ADDENDUM NO. 1
TO
CITY OF AUBURN, MAINE
2017 RECONSTRUCTION PROJECT
April 25, 2017

This addendum amends and /or supplements the bid documents as indicated below. Only these items alter the bid documents. Any verbal discussions or responses are hereby declared null and void. Please acknowledge this addendum on the attached Bid Form.

| Scale | 1" = 30' | | |

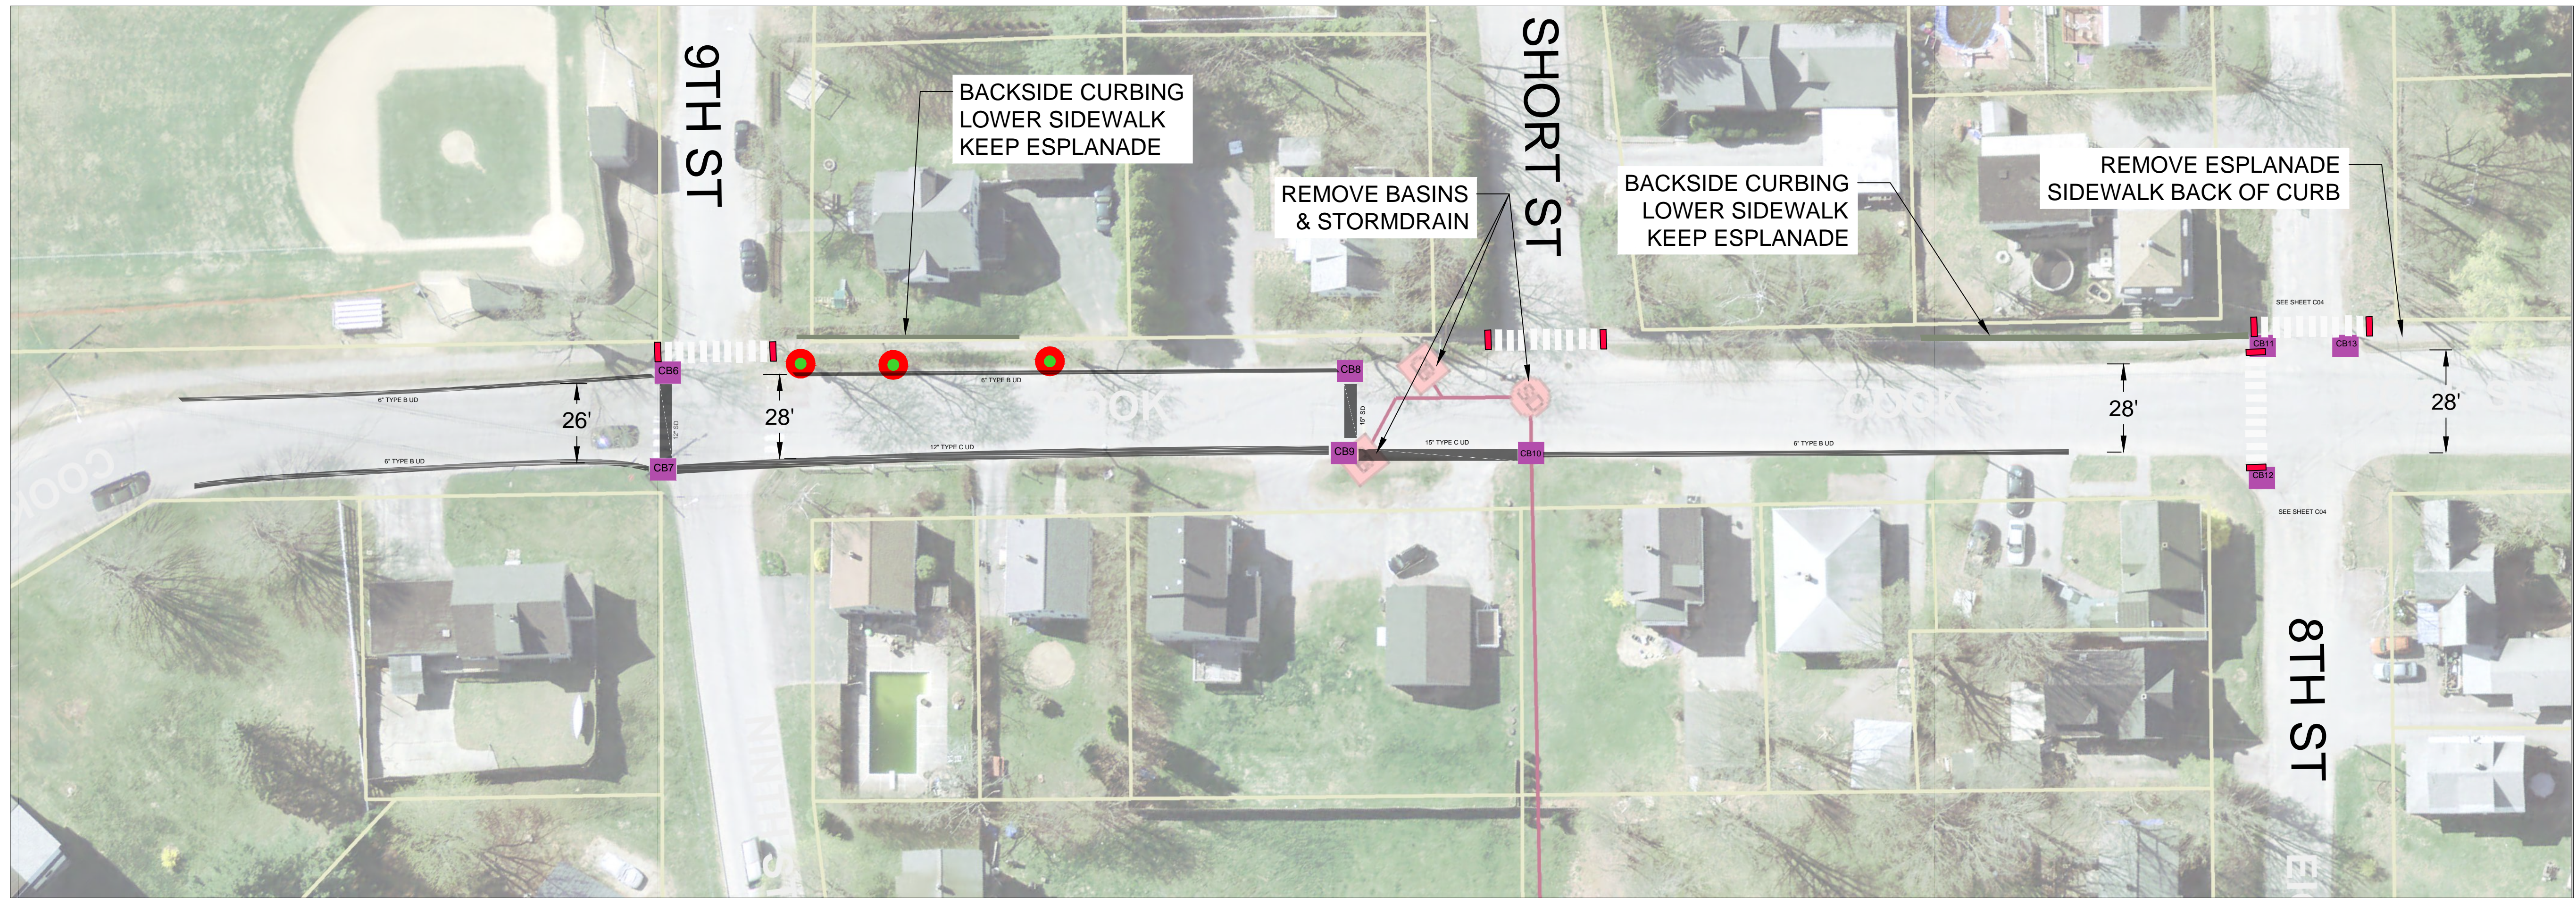
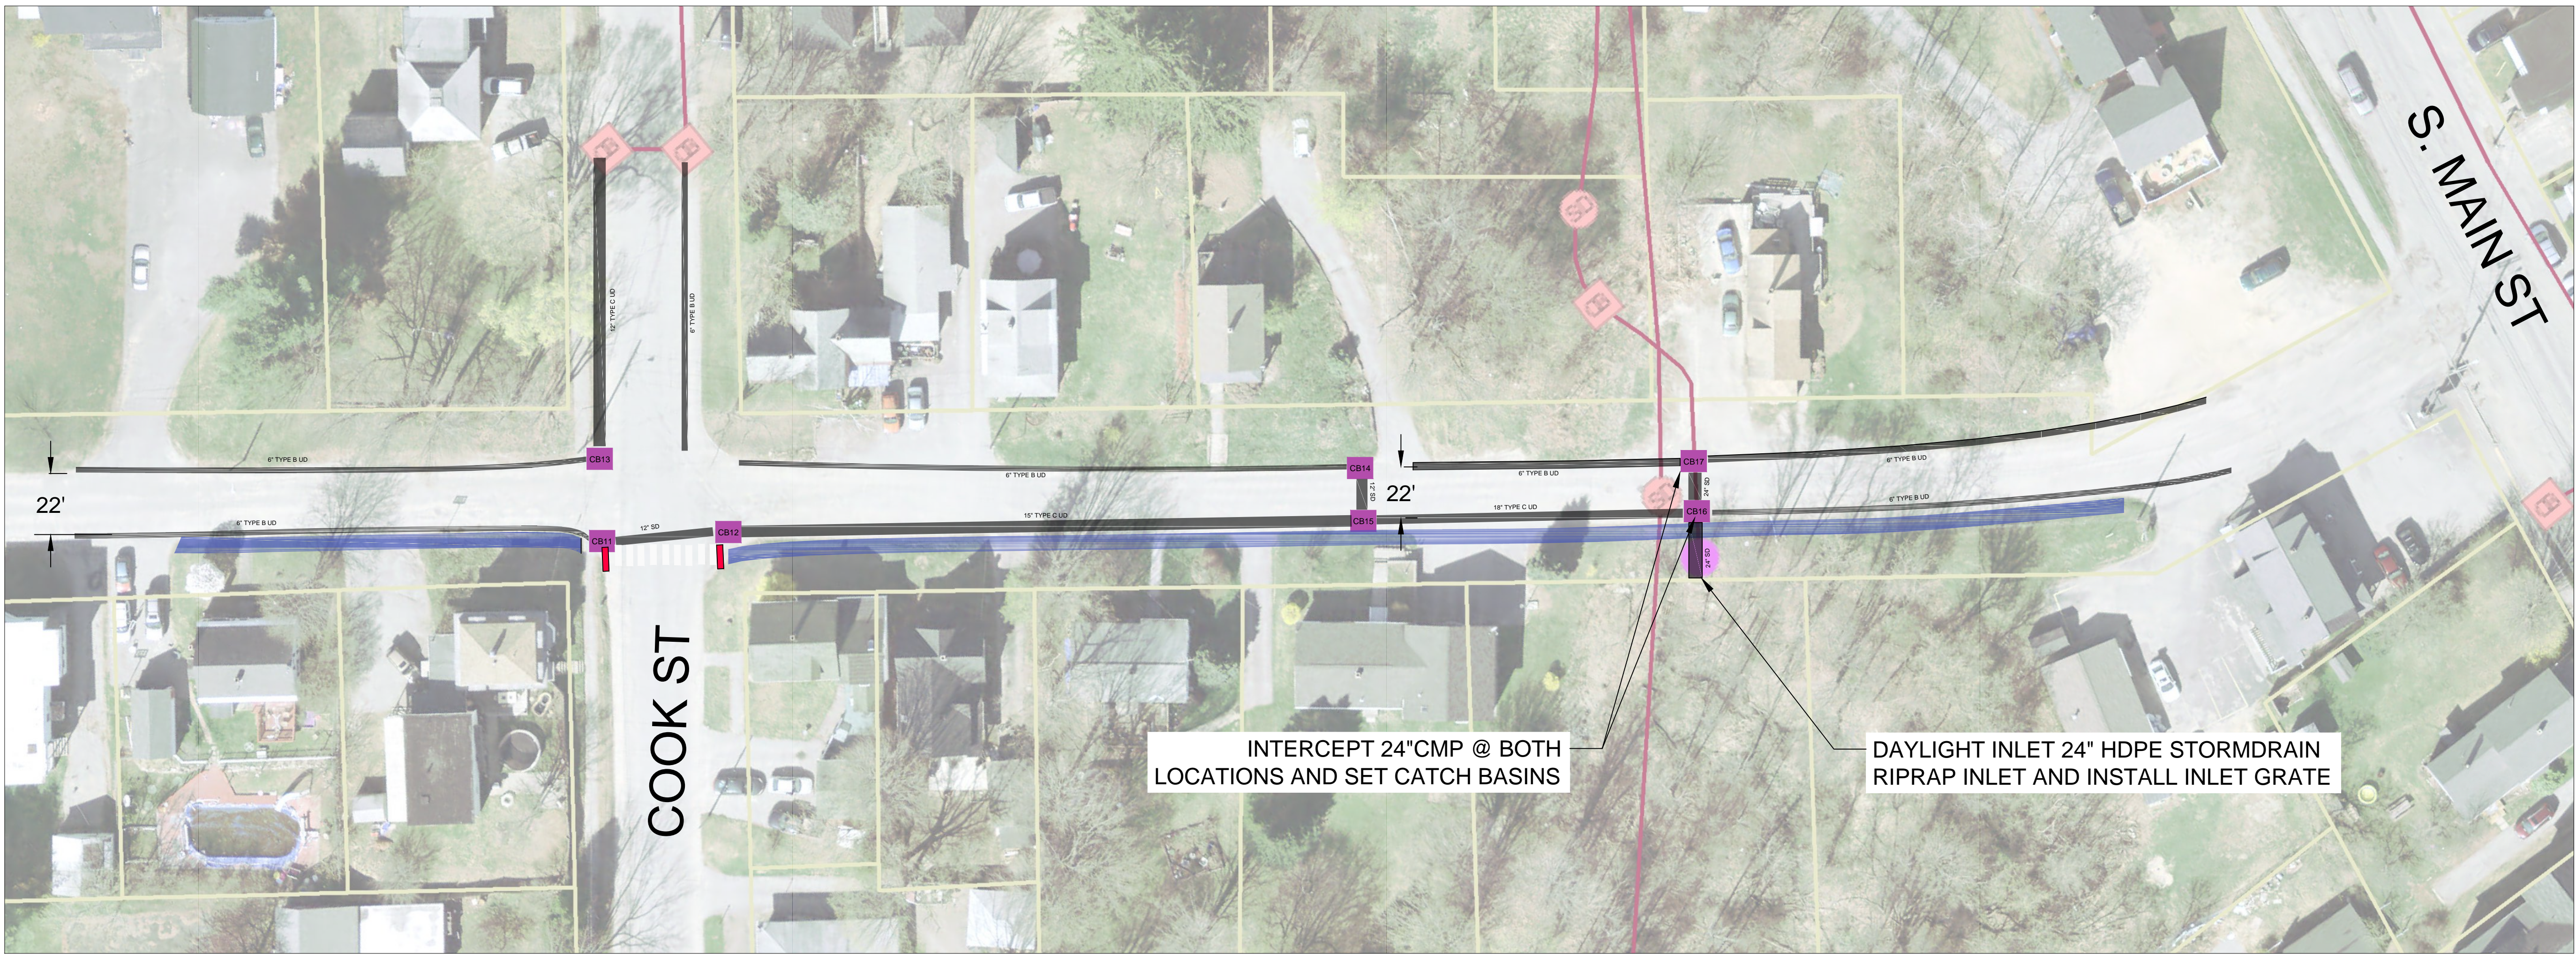
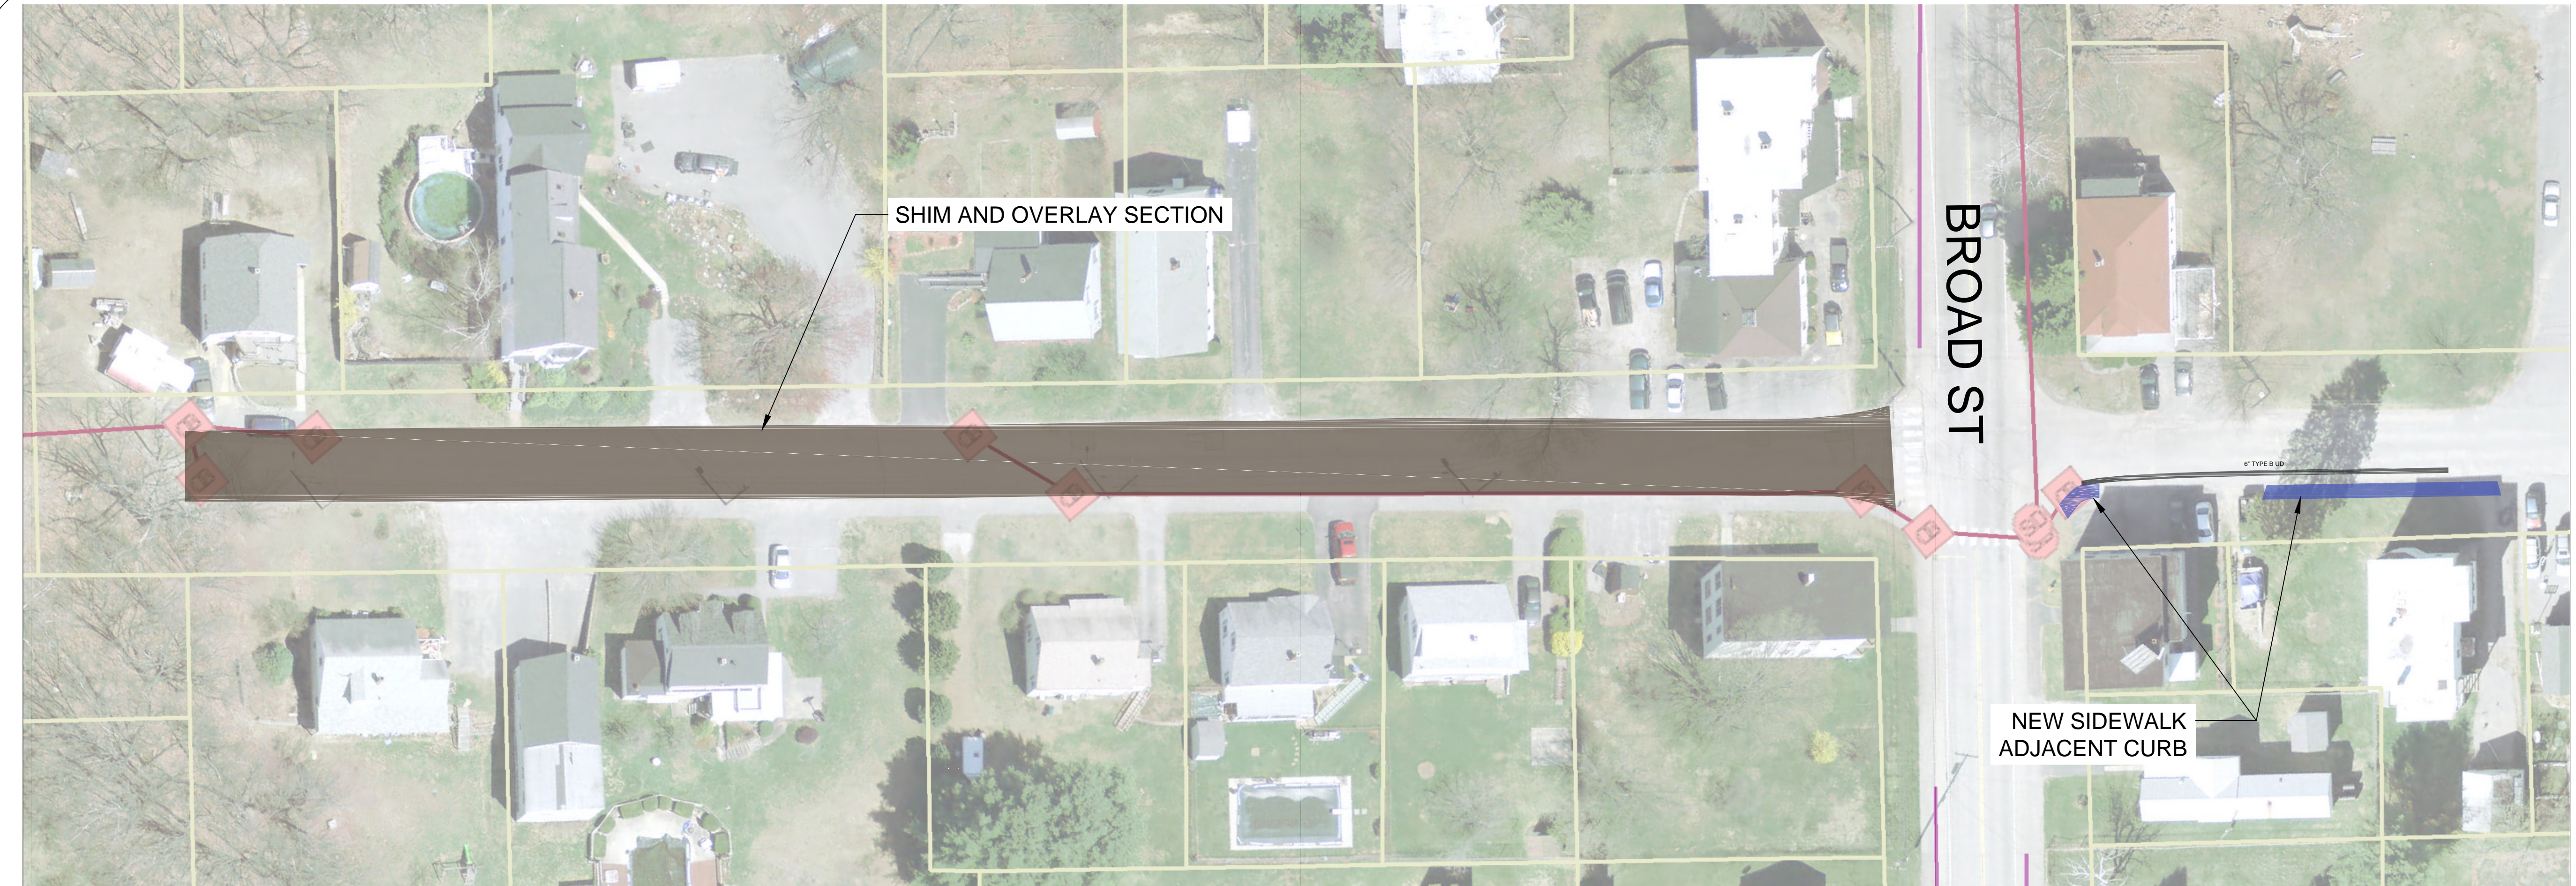
Question: The listed out road widths in the Scope of Work Section is the proposed widths?

Answer: Correct, the plan is to keep a consistent road width per section of road close to what exists. Example Cook Street from South Main Street to Bolster Street is between 22.5' and 25' in width, so proposing to carry it as 24' width. The widths can also be found on Appendix A.
